# NRC Technical Basis for CASS aging management

# MRP 2015-025 vs. BWRVIP-100

**Slide 2**

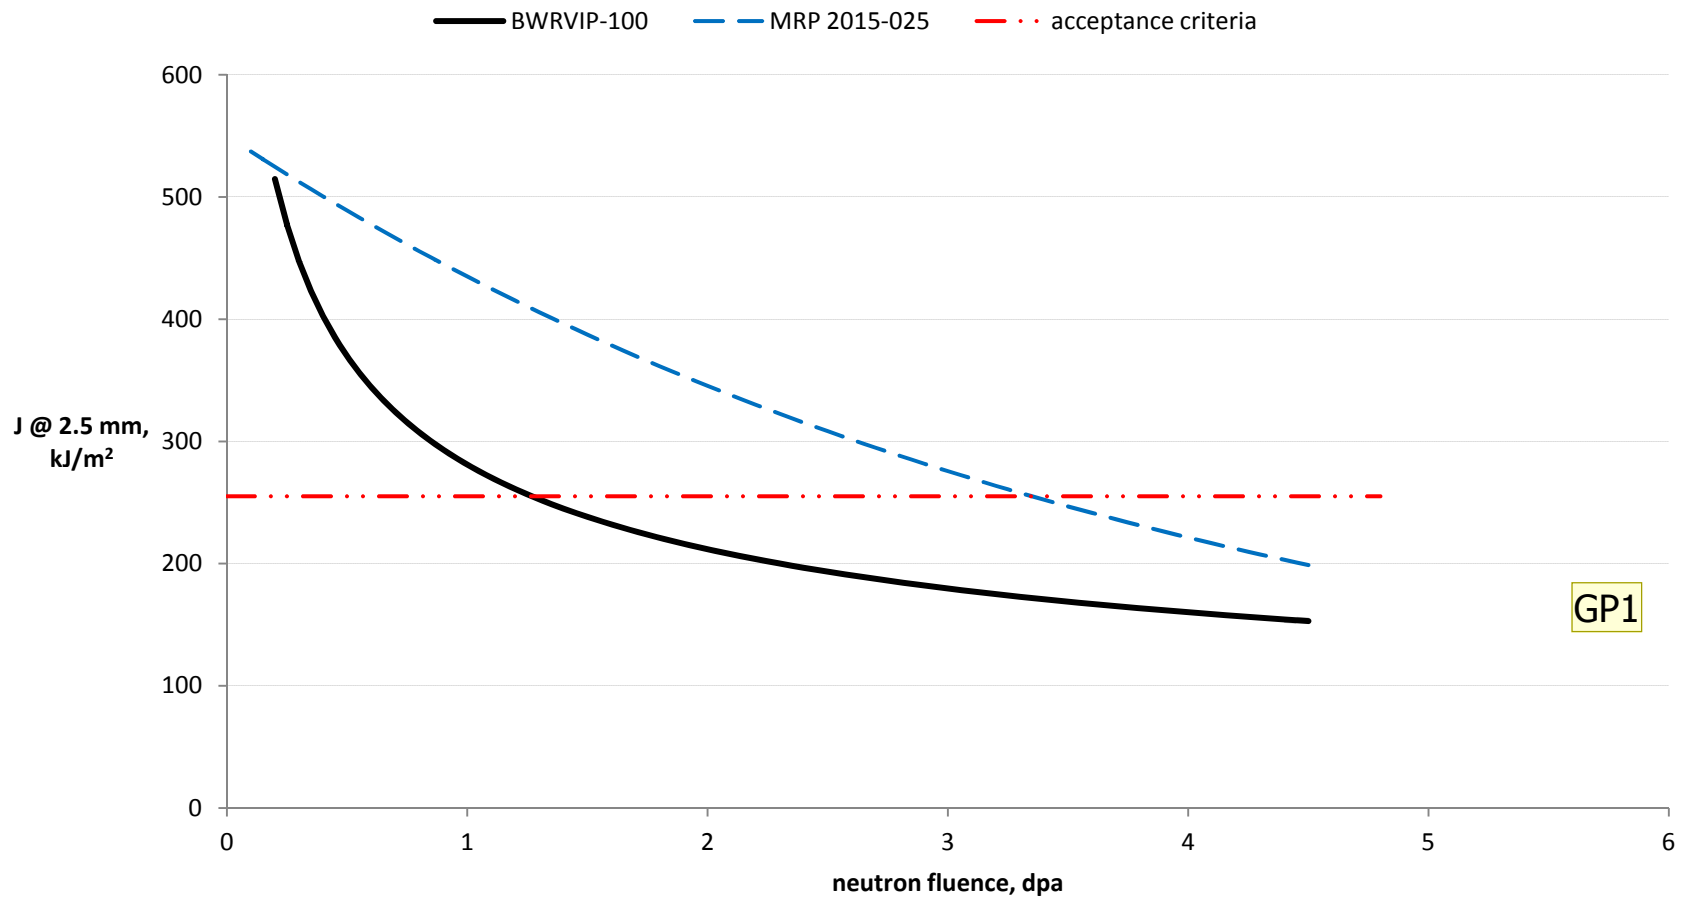
isn't this correct for our position?

## Slide 4

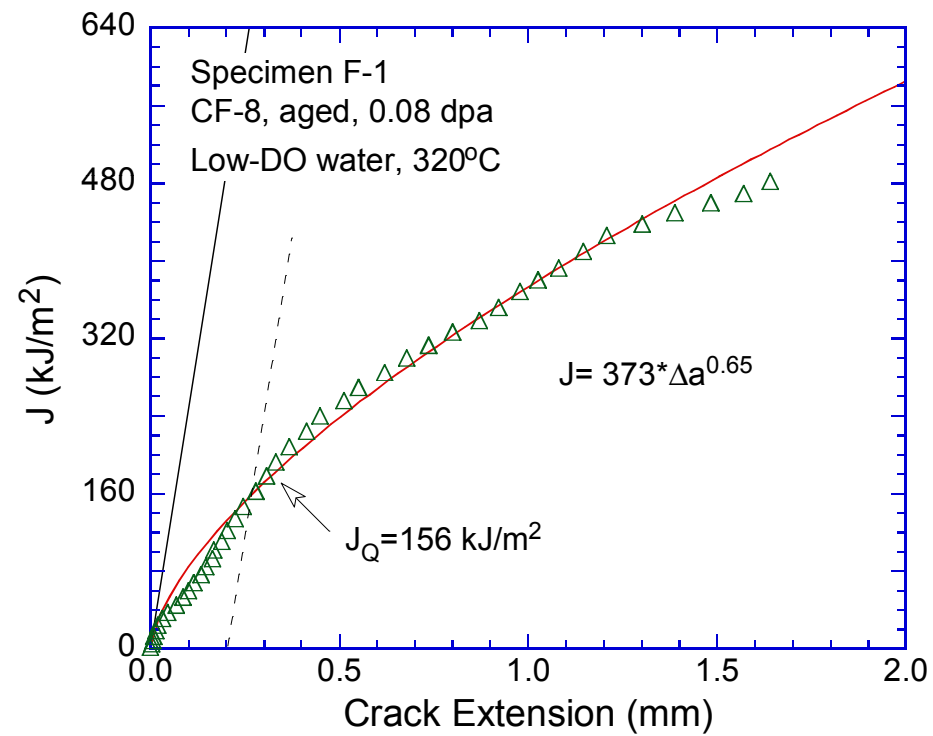
should be "loss of fracture toughness" instead of embrittlement
